NextEra Energy Canada, ULC

Addendum to the Design and Operations Report – Bluewater Wind Energy Centre

March, 2013

Bluewater Wind Energy Centre
Project Modifications Report

Figure 2.1

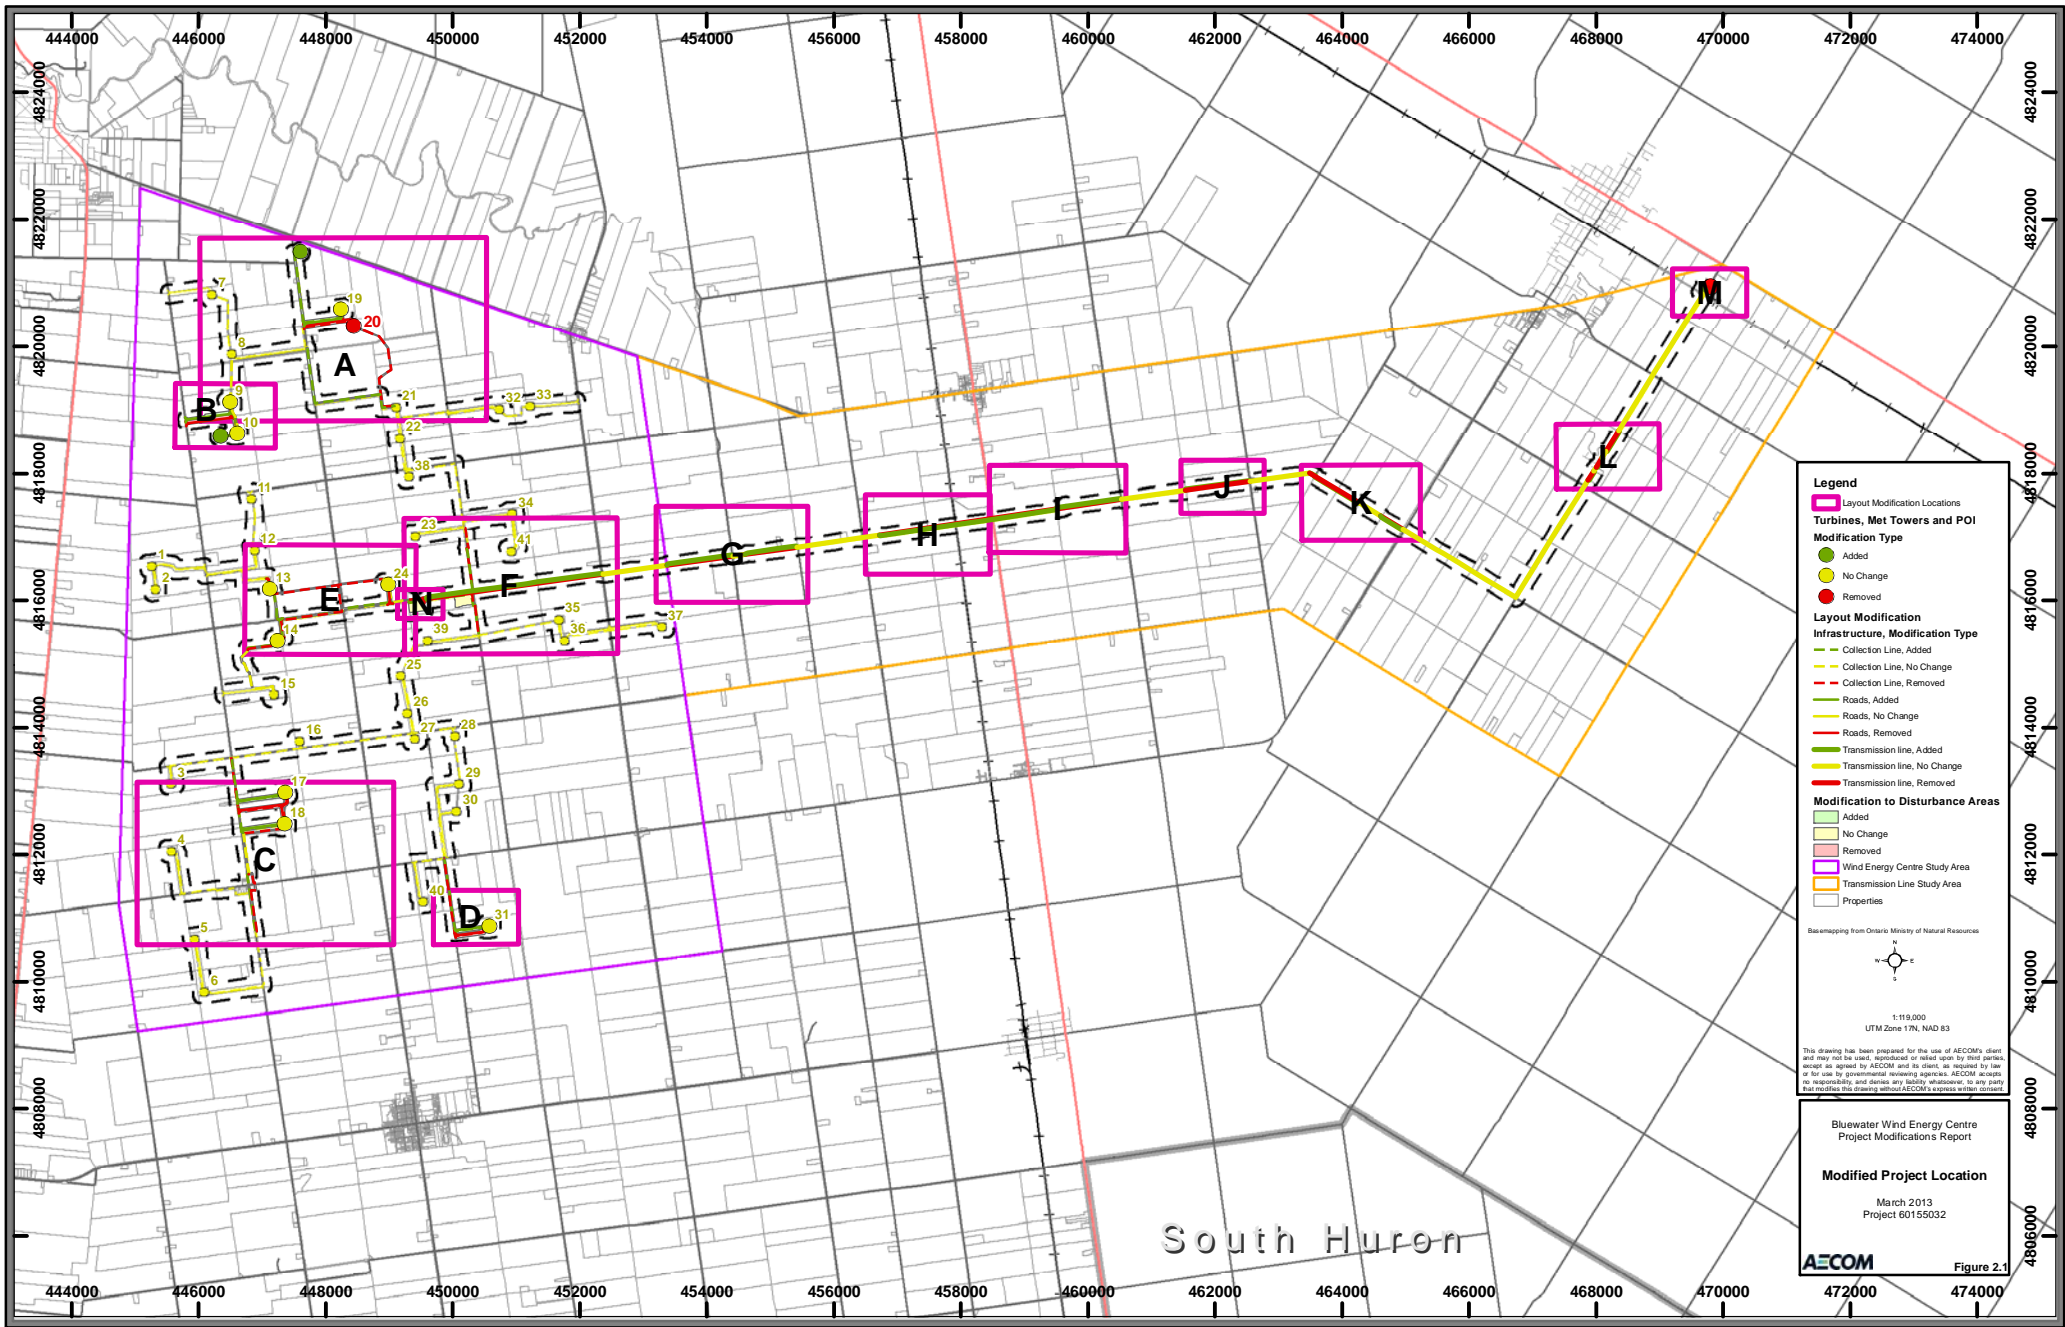
Label on Figure 2-1	Proposed Modification	Rationale for Proposed Modification	New Potential Environmental Effects	New Mitigation Measures
A	A1: Removal of Turbine 20 and associated access road and collection line, and provision of new access road to Turbine 19	Land owner no longer participating in project.	None – no new natural heritage or water body features within 120 m; area previously studied for cultural heritage.	N/A
	A2: Addition of meteorological (met) tower and associated infrastructure on private property	The met tower is required to obtain critical data to ensure the safe and efficient operation of the Project. As per amendment to O.Reg. 359/09, met towers are now considered to be part of a renewable energy generation facility and therefore this tower was added to the assessment.	None – no new natural heritage or water body features within 120 m; area previously studied for cultural heritage.	N/A

A3: Relocation of collection line to Turbine 19 (from Turbine 21) – to travel west on north side of private property and north in the Goshen Line right-of-way	Relocation of the collection line is necessary following the removal of Turbine 20.	Cultural Heritage: • Locations 33 and 34 documented.	Cultural Heritage: • Stage 3 assessment of Locations 33 and 34.
B	B1: Relocation of access road to Turbine 9 – to be relocated to south side of private property – and minor shift to disturbance area associated with Turbine 10	As per land owner request for relocation of access road. Minimize impacts to current land use and agricultural practices.	None – no new natural heritage or water body features within 120 m; area previously studied for cultural heritage.	N/A
	B2: Addition of met tower and associated infrastructure on private property	The met tower is required to obtain critical data to ensure the safe and efficient operation of the Project. As per amendment to O.Reg. 359/09, met towers are now considered to be part of a renewable energy generation facility and therefore this tower was added to the assessment.	None – no new natural heritage or water body features within 120 m; area previously studied for cultural heritage.	N/A

C	C1: Realignment of access road and collection line to Turbine 17 – to travel directly back from Bronson Line	As per land owner request for separate access road. Minimize impacts to current land use and agricultural practices.	None – no new natural heritage or water body features within 120 m; area previously studied for cultural heritage.	N/A
	C2: Addition of crane path between Turbines 17 and 18 (located primarily within footprint of infrastructure that is being removed)	Proposed to reduce cost of construction.	None – no new natural heritage or water body features within 120 m; area previously studied for cultural heritage.	N/A
	C3: Realignment of access road and collection line to Turbine 18 – to travel directly back from Bronson Line	As per land owner request for separate access road. Minimize impacts to current land use and agricultural practices.	Natural Heritage: • Access road proposed within 120 m of natural area 450. Feature previously studied; identified as Significant Woodland (Woodland E) and Generalized Candidate Significant Wildlife Habitat (Amphibian Woodland Breeding Habitat and Habitat for Species of Conservation Concern). Feature treated as Significant Amphibian Woodland Breeding Habitat (AWO-12) with commitment to complete pre-construction evaluation of significance studies. New potential effects associated with access road construction near this feature include: • Accidental intrusion into natural feature resulting in habitat damage; • Disruption of amphibians moving to breeding pools and home range; • Possible indirect effects on breeding pool condition through changes to surface water drainage patterns resulting from access road construction; and • Risk of mortality to amphibians moving between breeding pools and home range due to vehicular collisions along access road	Natural Heritage: • For Amphibian Woodland Breeding Habitat AWO-12 (if determined to be significant), mitigation measures will be the same as described in the approved NHA for other access roads proposed near amphibian woodland breeding habitat features (Section 5.4).

C4: Realignment of collection line at Bronson Line / Kippen Road to follow Bronson Line right of way	Land owner no longer participating in project.	None – no new natural heritage or water body features within 120 m; area previously studied for cultural heritage.	N/A
D	Realignment of access road to Turbine 31 – to travel directly back from Blind Line	As per land owner request for realignment of access road. Minimize impacts to current land use and agricultural practices.	None – no new natural heritage or water body features within 120 m; area previously studied for cultural heritage.	N/A

Label on Figure 2-1	Proposed Modification	Rationale for Proposed Modification	New Potential Environmental Effects	New Mitigation Measures
E	Realignment of collection line between Turbines 13, 14 and 24	Land owner no longer participating in project	<p>Natural Heritage:</p> <ul style="list-style-type: none"> Collection line proposed to be installed beneath natural area 487 via directional drilling. Feature previously studied; identified as Significant Woodland (Woodland K), Candidate Significant Amphibian Woodland Breeding Habitat (AWO-06), and Generalized Candidate Significant Wildlife Habitat (Bat Maternity Colony, Mature Forest Stand, and Habitat for Species of Conservation Concern). New potential environmental effects associated with collection line installation under these features: <ul style="list-style-type: none"> Potential for unplanned intrusion into Significant Woodland Feature K in event of equipment malfunction due to installation of collection line via horizontal directional drilling; and Potential for unplanned intrusion into Significant Amphibian Woodland Breeding Habitat (AWO-06) and Generalized Candidate Significant Wildlife Habitat in natural area 487 in the event of equipment malfunction due to installation of collection line via horizontal directional drilling. <p>Water Bodies:</p> <ul style="list-style-type: none"> Effects associated with new crossing of a water body include: <ul style="list-style-type: none"> Release of pressurized drilling fluids into watercourses from fractures in substrate (also known as 'frac-out'). Change to groundwater flow patterns, which may affect groundwater discharge to watercourses. Increase in erosion and sedimentation from the entry and exit drill holes required for the directional drilling activities. Release / discharge of sediment laden runoff from the construction area. Soil/water contamination by oils, grease and other materials from accidental spills and release of contaminants from equipment. 	<p>Natural Heritage:</p> <ul style="list-style-type: none"> For Significant Woodland K, Amphibian Woodland Breeding Habitat AWO-06 (if determined to be significant) and Generalized Candidate Significant Wildlife Habitat in natural area 487, additional mitigation measures included in the EIS that are the same as described in the approved NHA for collection line installation via directional drilling beneath other Significant Woodlands (Section 5.5) and Generalized Candidate Significant Wildlife Habitat (Section 5.3.2.1). <p>Water Bodies:</p> <ul style="list-style-type: none"> Correct maintenance of machinery. Minimize vehicle traffic on exposed soils and sensitive slopes. Locate facilities where contaminants are handled at least 30 m away from water bodies. Develop and implement an erosion and sediment control plan. Develop a spill response plan. Control soil / water contamination through best management practices. Conduct all drilling by licensed drillers in accordance with Ontario Water Resources Act, R.S.O. 1990. Locate drill entry and exit pits at least 30 m from water bodies. Collect drill cuttings as they are generated, and place in a soil bin or bag for off-site disposal. Ensure drill depth is at an appropriate depth below the water body to reduce the risk of a 'frac-out'. Monitor water bodies for signs of surface disturbance. Develop a 'frac-out' contingency plan.

F	<p>F1: Relocation of transmission line from municipal right-of-way onto private property</p> <p>F2: Relocation of transmission line from municipal right-of-way onto private property</p> <p>F3: Relocation of transmission line from municipal right-of-way onto private property</p>	<p>Landowner has agreed to participate in project.</p> <p>Avoid conflicts with existing infrastructure in the right-of-way.</p> <p>Landowner has agreed to participate in project.</p> <p>Avoid conflicts with existing infrastructure in the right-of-way.</p> <p>Landowner has agreed to participate in project.</p> <p>Avoid conflicts with existing infrastructure in the right-of-way.</p>	<p>None – no new natural heritage or water body features within 120 m; area previously studied for cultural heritage.</p> <p>Natural Heritage:</p> <ul style="list-style-type: none"> Transmission line is proposed within natural area 514 (vegetation removal required). New site investigation and evaluation of significance studies completed; feature confirmed to be a Significant Woodland (Woodland AJ) and treated as a Significant Bat Maternity Colony (BMC-15) with commitment to complete pre-construction evaluation of significance studies. New potential effects associated with tree removal in these features include: <ul style="list-style-type: none"> Loss of up to 0.1 ha of forest cover in Significant Woodland Feature AJ; Clearing of vegetation for maintenance of the transmission line, resulting in accidental damage to Significant Woodland AJ; Displacement and/or mortality of nursing female and juvenile bats resulting from vegetation clearing for transmission line construction within Bat Maternity Colony BMC-15; Removal of confirmed significant cavity trees or other suitable cavity trees resulting from vegetation clearing for the transmission line within Bat Maternity Colony BMC-15; and Noise disturbance to and/or avoidance behaviour of bats during construction within Bat Maternity Colony BMC-15. <p>None – no new natural heritage or water body features within 120 m; area previously studied for cultural heritage.</p>	<p>N/A</p> <p>Natural Heritage:</p> <ul style="list-style-type: none"> Establish an area of forest equal in area to the cleared area through tree planting and management (e.g., in partnership with a local Conservation Authority). Details of the afforestation plan will be provided to MNR in a Compensation Plan. Perform vegetation clearing for construction outside of the breeding bird season and bat maternal period (May 1 to July 31). If this is not possible, MNR will be consulted regarding mitigation measures that may be required. Clearly stake area to be cleared. Fell trees with a chainsaw toward the construction area to reduce damage to adjacent vegetation being retained. Damaged tree roots will be cut clean as soon as possible and exposed roots covered in approved topsoil. This work to be carried out under supervision of an Arborist or Forester. Prepare a tree preservation plan which identifies specific trees to be removed and whether each tree contains a cavity suitable for potential use as a bat maternity colony. For each suitable cavity tree to be removed, a bat house will be installed in the closest suitable woodland habitat (the remainder of the woodland for the affected habitat). Details will be determined through consultation with MNR. Tree removal will occur during daylight hours. Schedule vegetation clearing for operational maintenance to occur outside of the breeding bird season (May 1 to July 31). Undertake active nest surveys if vegetation removal must take place during this period. <p>N/A</p>

Label on Figure 2-1	Proposed Modification	Rationale for Proposed Modification	New Potential Environmental Effects	New Mitigation Measures
G	G1: Relocation of transmission line from municipal right-of-way onto private property	Landowner has agreed to participate in project. Avoid conflicts with existing infrastructure in the right-of-way.	None – no new natural heritage or water body features within 120 m; area previously studied for cultural heritage.	N/A
	G2: Relocation of transmission line from municipal right-of-way onto private property	Landowner has agreed to participate in project. Avoid conflicts with existing infrastructure in the right-of-way.	Water Bodies: • No effects provided that transmission poles are set back 10-15 m from top of bank.	N/A
	G3: Relocation of transmission line from municipal right-of-way onto private property	Landowner has agreed to participate in project. Avoid conflicts with existing infrastructure in the right-of-way.	None – no new natural heritage or water body features within 120 m; area previously studied for cultural heritage.	N/A

H	Relocation of transmission line from municipal right-of-way onto private property	Landowner has agreed to participate in project. Avoid conflicts with existing infrastructure in the right-of-way.	None – no new natural heritage or water body features within 120 m; area previously studied for cultural heritage.	N/A
I	I1: Relocation of transmission line from municipal right-of-way onto private property	Landowner has agreed to participate in project. Avoid conflicts with existing infrastructure in the right-of-way.	Natural Heritage: • None – no new natural heritage features within 120 m. Water Bodies: • No effects provided that transmission poles are set back 10-15 m from top of bank.	N/A
	I2: Relocation of transmission line from municipal right-of-way onto private property	Landowner has agreed to participate in project. Avoid conflicts with existing infrastructure in the right-of-way.	Natural Heritage: • Transmission line is proposed within natural area 551 (vegetation removal required). New site investigation and evaluation of significance studies completed; feature confirmed to be a Significant Woodland (Woodland AO) and Habitat for Bird Species of Conservation Concern (Red-Headed Woodpecker) (SCB-02). New potential effects associated with tree removal in these features include: • Loss of up to 0.2 ha of forest cover in Significant Woodland Feature AO; • Clearing of vegetation for maintenance of the transmission line, resulting in accidental damage to Significant Woodland AO; • Removal of vegetation (up to 0.1 ha) within significant feature resulting in habitat damage from clearing for transmission line in Red-headed Woodpecker Habitat Feature SCB-02; • Red-Headed Woodpecker Breeding Habitat Feature (SCB-02) may be disturbed by routine maintenance of the transmission line corridor; and • Noise disturbance to breeding Red-headed Woodpeckers during transmission line construction within Red-headed Woodpecker Habitat Feature SCB-02. Water Bodies: • No effects provided that transmission poles are set back 10-15 m from top of bank.	Natural Heritage: • Establish an area of forest equal in area to the cleared area through tree planting and management (e.g., in partnership with a local Conservation Authority). Details of the afforestation plan will be provided to MNR in a Compensation Plan. • Perform vegetation clearing for construction outside of the breeding bird season (May 1 to July 31). If this is not possible: • maintain a 20 m buffer around any active Red-headed Woodpecker nest within which no vegetation removal will occur; and • MNR will be consulted regarding mitigation measures that may be required. • Clearly stake area to be cleared. • Fell trees with a chainsaw toward the construction area to reduce damage to adjacent vegetation being retained. • Damaged tree roots will be cut clean as soon as possible and exposed roots covered in approved topsoil. This work to be carried out under supervision of an Arborist or Forester. • Minimize the area of tree removal within the natural area to the extent possible. • Remove trees by hand-held equipment and drag them out of the natural area to minimize soil disturbance. If possible, leave some woody debris to decompose naturally. • Any vehicles used within the natural area will have wide-based tires. Tracked vehicles will be avoided. • Schedule vegetation clearing for operational maintenance to occur outside of the breeding bird season (May 1 to July 31). If vegetation clearing takes place during this timing window, nest searches will be conducted by qualified Biologist.

J	J1: Relocation of transmission line from municipal right-of-way onto private property	Landowner has agreed to participate in project. Avoid conflicts with existing infrastructure in the right-of-way.	Natural Heritage: • Transmission line is proposed within natural area 555. New site investigation and evaluation of significance studies completed; feature confirmed to be a Significant Woodland (Woodland AP). New potential effects associated with tree removal in this feature include: • Loss of up to 0.2 ha of forest cover in Significant Woodland Feature AP; and • Clearing of vegetation for maintenance of the transmission line, resulting in accidental damage to Significant Woodland AP. Cultural Heritage: • Location 29 documented.	Natural Heritage: • Establish an area of forest equal in area to the cleared area through tree planting and management (e.g., in partnership with a local Conservation Authority). Details of the afforestation plan will be provided to MNR in a Compensation Plan. • Perform vegetation clearing for construction outside of the breeding bird season (May 1 to July 31). If this is not possible, MNR will be consulted regarding mitigation measures that may be required. • Clearly stake area to be cleared. • Fell trees with a chainsaw toward the construction area to reduce damage to adjacent vegetation being retained. • Damaged tree roots will be cut clean as soon as possible and exposed roots covered in approved topsoil. This work to be carried out under supervision of an Arborist or Forester. • Schedule vegetation clearing for operational maintenance to occur outside of the breeding bird season (May 1 to July 31). Undertake active nest surveys if vegetation removal must take place during this period. Cultural Heritage: • Stage 3 assessment of Location 29.

J2: Relocation of transmission line from municipal right-of-way to follow unopened municipal right-of-way	Avoid conflicts with existing infrastructure in the right-of-way.	Natural Heritage: • Transmission line is proposed within natural area 582. New site investigation and evaluation of significance studies completed; not a significant feature. Water Bodies: • No effects provided that transmission poles are set back 10-15 m from top of bank.	Natural Heritage: • N/A

Label on Figure 2-1	Proposed Modification	Rationale for Proposed Modification	New Potential Environmental Effects	New Mitigation Measures
K	K1: Relocation of transmission line from municipal right-of-way onto private property	Landowner has agreed to participate in project. Avoid conflicts with existing infrastructure in the right-of-way.	None – no new natural heritage or water body features within 120 m. Area subsequently studied for cultural heritage – no new resources affected.	N/A
	K2: Relocation of transmission line from municipal right-of-way onto private property	Landowner has agreed to participate in project. Avoid conflicts with existing infrastructure in the right-of-way.	Water Bodies: • No effects provided that transmission poles are set back 10-15 m from top of bank.	N/A
	K3: Relocation of transmission line from municipal right-of-way onto private property	Landowner has agreed to participate in project. Avoid conflicts with existing infrastructure in the right-of-way.	None – no new natural heritage or water body features within 120 m; area previously studied for cultural heritage.	N/A

L	Relocation of transmission line from municipal right-of-way onto private property	Landowner has agreed to participate in project. Avoid conflicts with existing infrastructure in the right-of-way.	Water Bodies: • No effects provided that transmission poles are set back 10-15 m from top of bank.	N/A
M	Relocation of Point of Interconnect (POI) from Seaforth substation property to private property	Land owner agreed to participate in the project Avoid conflicts with existing infrastructure.	None – no new natural heritage or water body features within 120 m; area previously studied for cultural heritage.	N/A
N	Relocation of substation within the same property parcel	Original location was in a floodplain.	None – no new natural heritage or water body features within 120 m; area previously studied for cultural heritage.	N/A
